COMMERCIAL DEVELOPMENT PLAN FOR PENROSE RV & BOAT STORAGE

NO.	REVISIONS
01	DESIGN
02	PLANNING REVIEW
	PLANNING REVIEW

SITE PLAN

C3.0

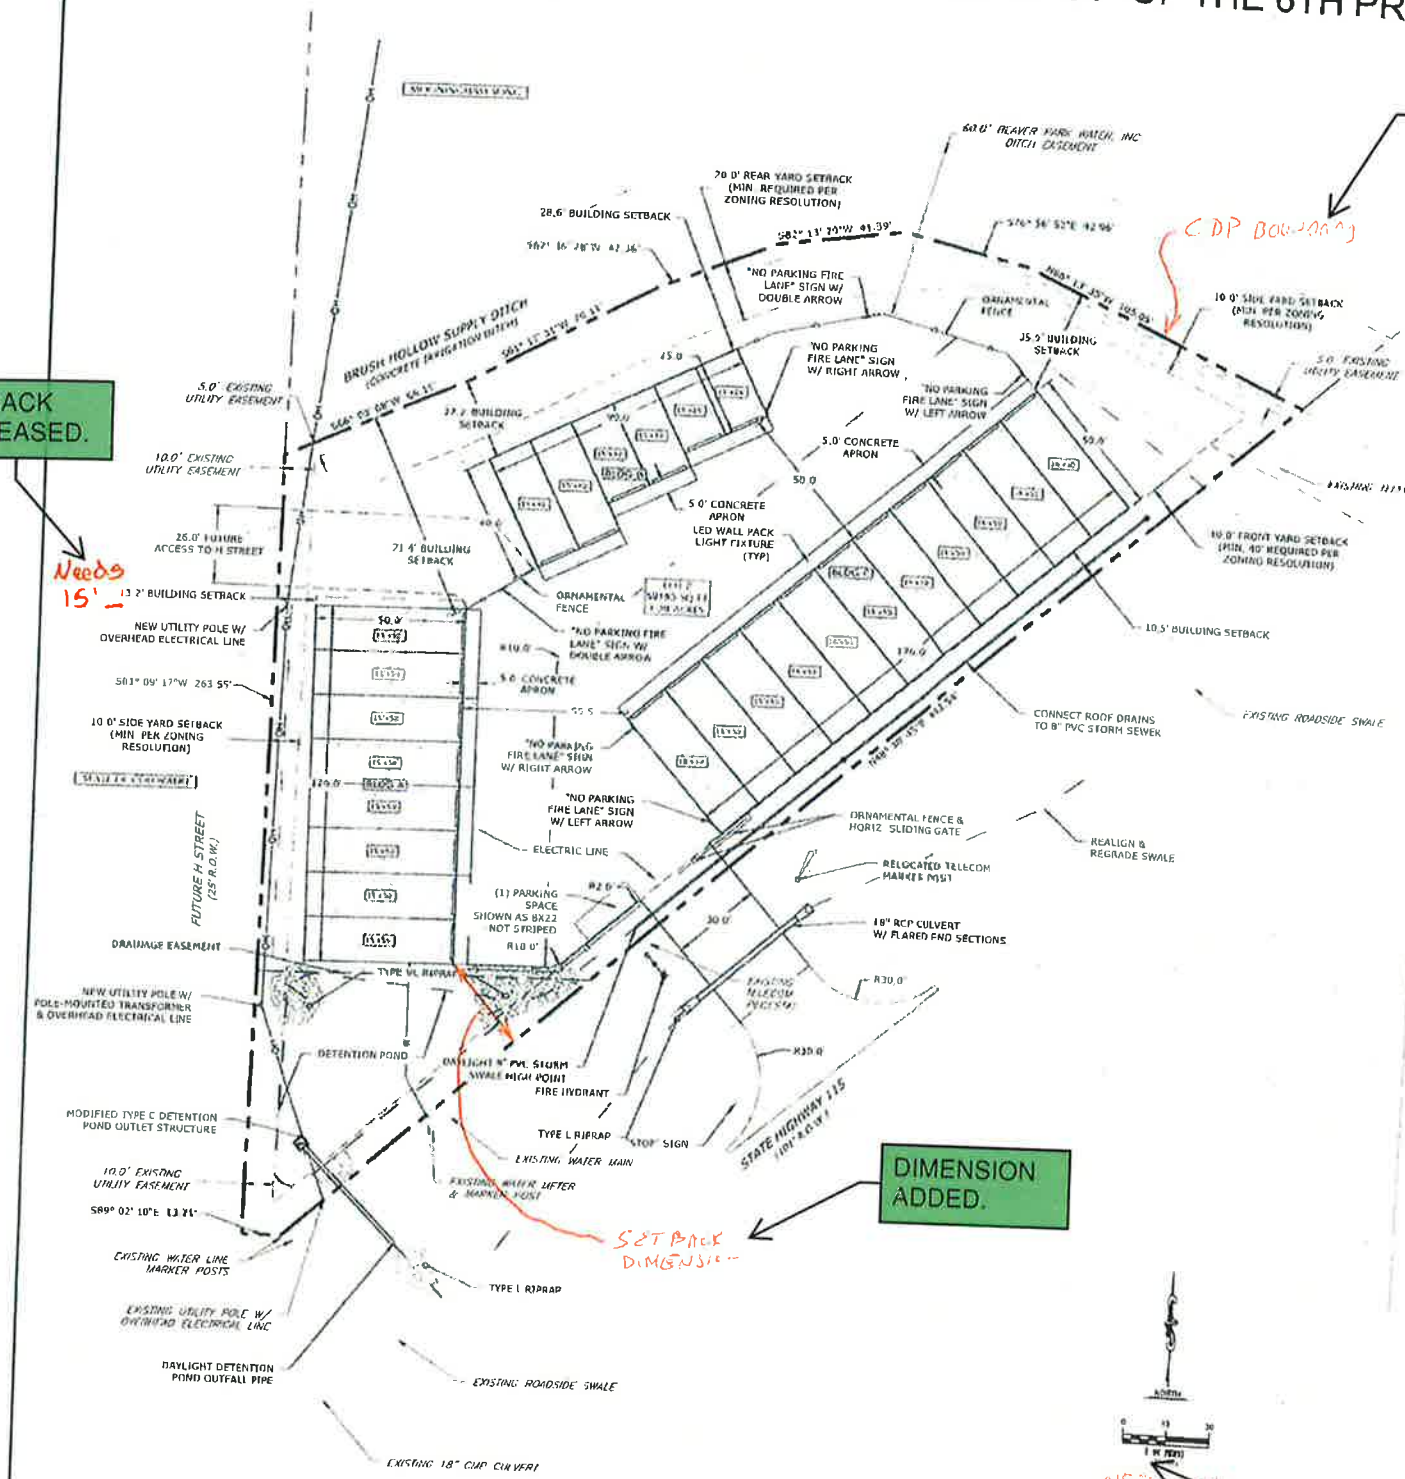
*MOVE
LEGAL DESCRIPTION
HERE*

*East side setback is proposed as 35.9'
Need to add side setback adj to street (H Street)*

Not legible

*NSD 2017
Scale*

Needs 15' -

MOVED.

REMOVED FROM SITE PLAN. REFER TO ARCH. ELEVATIONS.

ALREADY PROVIDED.

DIMENSION ADDED.

CALLOUT ADDED.

SETBACK INCREASED.

ADDED.
